Regarding the
Jordan Cove Export Terminal
Draft Environmental Impact Statement
Docket No. CP13-483

January 14, 2015

UNITED STATES LNG TERMINAL SAFE-SITING POLICY IS FAULTY

**Typical Tank(s)**

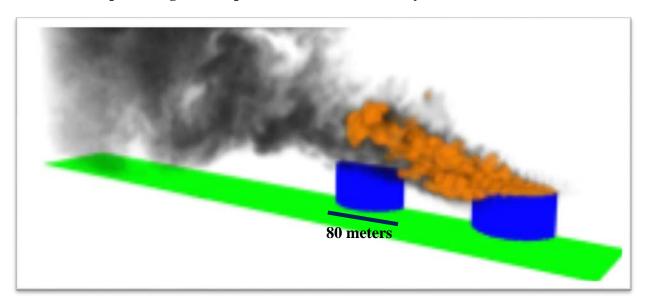
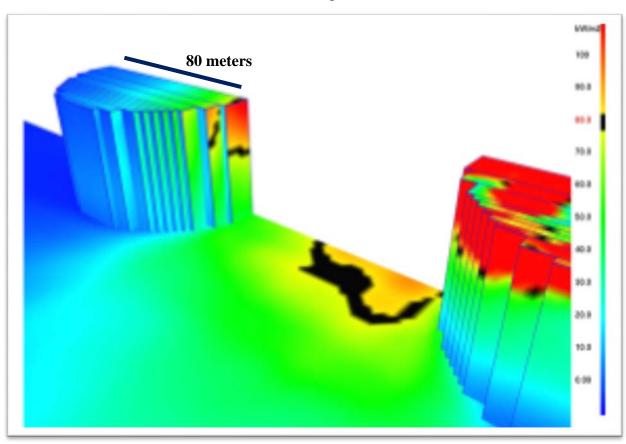
Professor Venart's study of this fire scenario raises serious questions regarding the possibility of massive failure of a full-containment LNG tank due to severe, long-term, fire heat exposure to the tank with such a fire atop it. We believe that if this Design Spill Fire is to be used to determine the fire-radiation exclusion zone, there must also be considered the potential for such a fire to cause catastrophic failure of the tank (or tanks), resulting in the rapid release (spill) of perhaps half a million gallons of burning LNG. Should that occur, the fire radiation distances from the earthen-berm tertiary containment provided would surely extend the estimated fire radiation exclusion zone requirements to provide for public safety well beyond the facility property lines, to say nothing of the potential for catastrophic damage to the entire facility. We present below excerpts from Venart's presentation to DOT's Pipeline and Hazardous Materials Safety Administration (PHMSA)[2] that illustrate our concerns for cascading failures following such a tank-top-fire-scenario.

Conclusions regarding tank-top fire and cascading failure scenario

- LNGFIRE3 has NOT been validated for the size of LNG fires anticipated for tank-top fires. Its use to establish conservative thermal exclusion zones is suspect.

- If not extinguished such a tank-top fire could possibly burn for 20-30 hours.
- NIST FDS CFD and experimental studies establish that the wind flowing around the sides of the tank tends to drag the flame down over the edge of the tank towards the ground. This exposes the concrete containment to high temperatures, radiant fluxes greater-than-design and thus thermal stresses with a potential for spalling, cracking, and other failure modes, thus loss of support to the interior mild steel moisture barrier and the insulating perlite.

- Thermal stresses to this complex system over the many hours of fire exposure could possibly cause collapse of the downwind edges of the Nickel steel primary containment and loss of LNG into the Perlite, a situation perhaps sufficient to result in total collapse of the containment system due to thermal stress. Under such conditions escalation of the event would be inevitable.

- The extent of the pool fire could now increase to the edges of any berm-impoundment surrounding the tank area, if provided, and a very much larger pool fire could result (of shorter duration).

- With two tanks, if one tank did not collapse, its adjacent neighbor would be exposed to heat fluxes greater than 80 kW/m^2 should the prevailing wind result in its flame exposure. Due to the increased fire size, plant processing areas could be adversely affected and the public radiation exclusion zone substantially increased.

Figure 4.13-1 from DEIS
Vapor Fences at Jordan Cove Facility

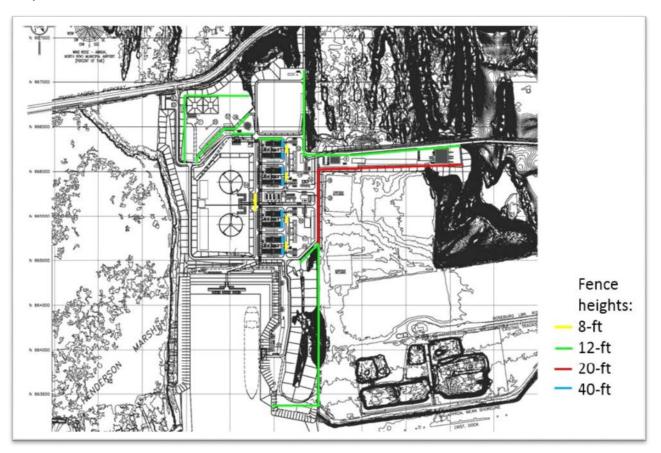
The vapor dispersion distances calculated using PHAST and FLACS, while extending in some cases slightly past the applicant's property boundaries, obviously could not have been determined by the (dispersion) models used without the applicant's provision of gas-impermeable vapor fences to retain the flammable cloud boundaries within the property boundary. The Figure below indicates the position of the proposed vapor fences; gas-impermeable concrete fences as tall as forty feet.

Perhaps most importantly, as vapor fences at the Jordan Cove Facility could (in addition to the spill-guidance trenches and impoundments themselves) provide a degree of partial confinement to the cloud, there is additional potential for run up to detonation, especially if the cloud contains more than a few percent ethane/propane or equivalent heavy components.

All of the figures presented in the DEIS of flammable vapor cloud travel distance for the LNG design spills illustrate simply that the vapor fences prevent travel (except in minor cases which FERC has provided exceptions for) beyond the applicant's property boundary. We believe these results entirely miss the point of the intention of the regulations – to provide for public safety. These figures appear to indicate that the authors of the application (Jordan Cove and their Consultants) believe that the hazard extent of these spills ends at the calculated lower flammable limit concentration reached by the cloud (the cloud boundaries depicted represent concentration LFL/2, as required by the regulation). However, this assumption was historically based on the fact that a reasonable limit on the fire damage from a vapor cloud fire, which would be of short duration, would not extend significantly beyond the flammable vapor concentration boundary. The parties that prepared the JCE DEIS must surely be aware of the serious potential for an unconfined vapor cloud explosion to extend well beyond the limits of the flammable cloud boundary. In the text above describing the Coast Guard's explosion tests at China Lake, we provided evidence of the potential for LNG clouds that contain small amounts of heavier-than-methane hydrocarbons to develop damaging overpressures. We focus on two of the figures presented in the JCE DEIS, both for the design spills from the LNG ship unloading line. The points we wish to emphasize are specified immediately following the figures.

Figure 4.13-7 from DEIS
LNG Jetting and Flashing Scenario from a Rupture of the Ship Loading Header

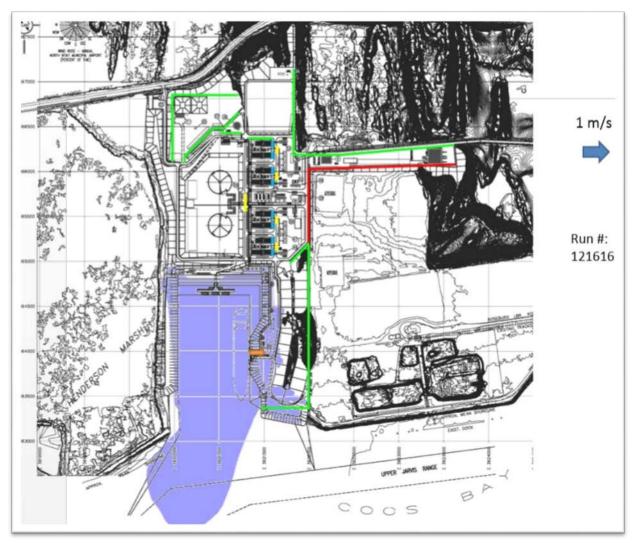
The area covered by the cloud in Figure 4.13.7 is estimated to be approximately 400 meters wide and 720 meters long (top to bottom in the figure). We estimate this gas cloud would be between 2 and 5 meters deep. The cloud envelops the LNG shipping berth, indicating that a ship at the berth would be completely surrounded by the flammable cloud. While the dense packing of equipment seen in the previous figure associated with the liquefaction trains is not inside the cloud, there are containment factors associated with the space between the sea wall and the carrier that could cause damaging flame accelerations leading to explosions. We wonder what an LNG ship's Master would say if she were informed that a flammable cloud of hydrocarbons was about to surround her ship.

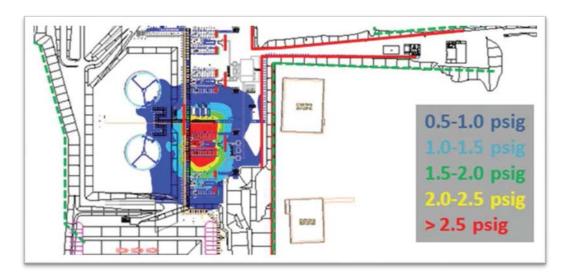
The DEIS at page 4-963 states the following. "… the propensity of a vapor cloud to detonate or produce damaging overpressures is influenced by the reactivity of the material, the level of confinement and congestion surrounding and within the vapor cloud, and the flame travel distance." We add that the potential flame travel distance is the distance that can be traversed by the flame in gas/air concentrations lying within the flammable region, i.e., between the LFL and UFL. This travel distance is in turn determined by the amount of flammable gas that is mixed with air in the cloud, and thus by the amount released into the atmosphere. The implications are clear; if a very large vapor cloud can form with large distances that can be traversed by a flame burning in the flammable region, the potential for flame acceleration increases.

While the DEIS presents explosion overpressure predictions for the mixed refrigerant gases, it dismisses the (UVCE) explosion hazards for LNG. We believe this cannot be justified for the following reasons:

- There are regions with linear dimensions of approximately 100 meters where the calculated pressures exceed 2.5 psig, but there is no specification of the maximum pressures reached. (See Figure 4.15-13 from the DEIS below.)
